***Docket Item #3 A-F
Landmark Gateway
520 South Van Dorn Street, 631 and 641 South Pickett Street***

Application	General Data	
Project Name: Landmark Gateway	PC Hearing:	January 6, 2009
	CC Hearing:	January 24, 2009
	If approved, DSUP expiration:	January 24, 2012 (36 months)
	Plan Acreage:	6.31 Acres
Location: 520 S. Van Dorn Street and 631 and 641 S. Pickett Street	Zone:	CG & I (current) CDD #17 (rezoning)
	Proposed Use:	Residential and Retail
	Dwelling Units:	431
	Gross Floor Area:	549,558 sf (35,436 sf retail)
Applicant: Green City Development, LLC, represented by J. Howard Middleton	Small Area Plan:	Landmark/Van Dorn
	Green Building:	Applying for LEED Certification

Purpose of Application
Approval for development of the first site within the Landmark/Van Dorn Corridor Plan planning area. The proposal includes three residential buildings with ground floor retail and implementation of the street network as outlined in the draft Plan.

Attachment #2: Building 3 Materials

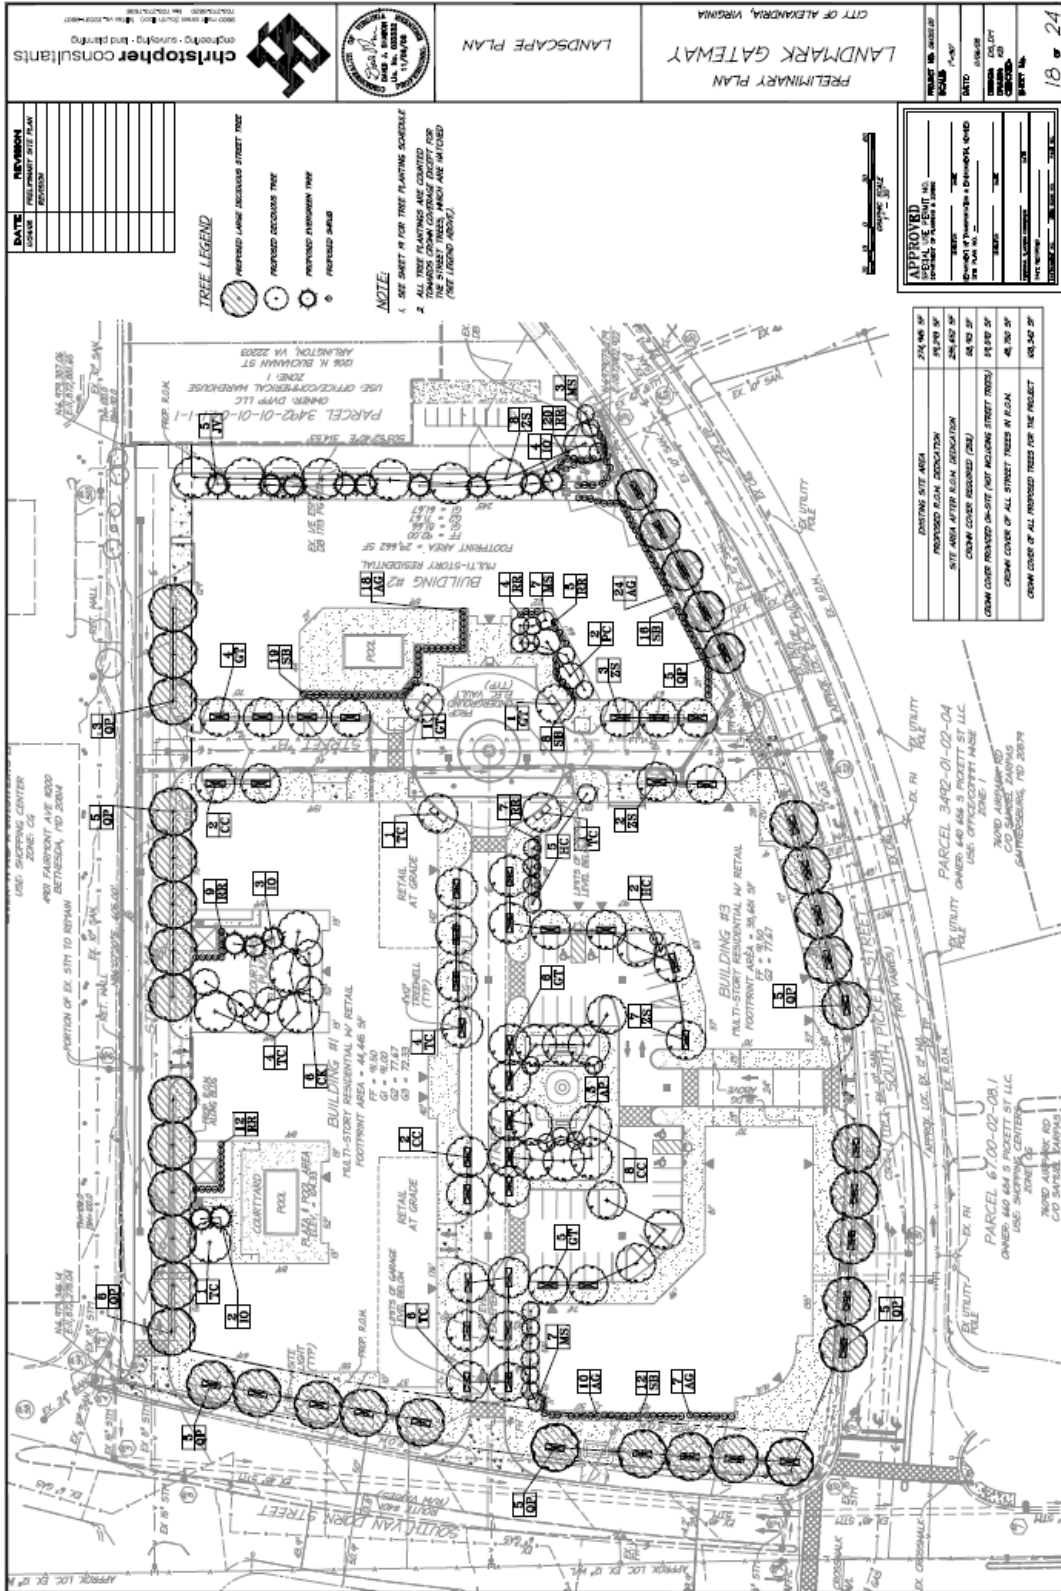
Staff strongly supports the architectural design of Building 3; however, staff is aware that some members of the community are very concerned about the design. Staff would support additional coordination with the community during the final site plan process to further refine some of the architectural details for this building.

- c. Color architectural elevations (front, side and rear) shall be submitted with the final site plan for each building.
 - d. All loading and garage doors shall be painted to match the color of the adjoining building material. Plan and section details of the conditions adjoining the garage and loading dock doors shall be provided as part of the final site plan. All loading and garage doors shall be an opaque screen or screen to minimize the projection of light from the garage onto the adjoining street.

- e. The applicant shall provide details including colors and materials for all balconies, decks, and rooftop spaces with the final site plans.
 - f. The buildings shall be designed to incorporate a variety of fenestration as represented in the submitted plans and refined to match the architectural style emulated in each building.
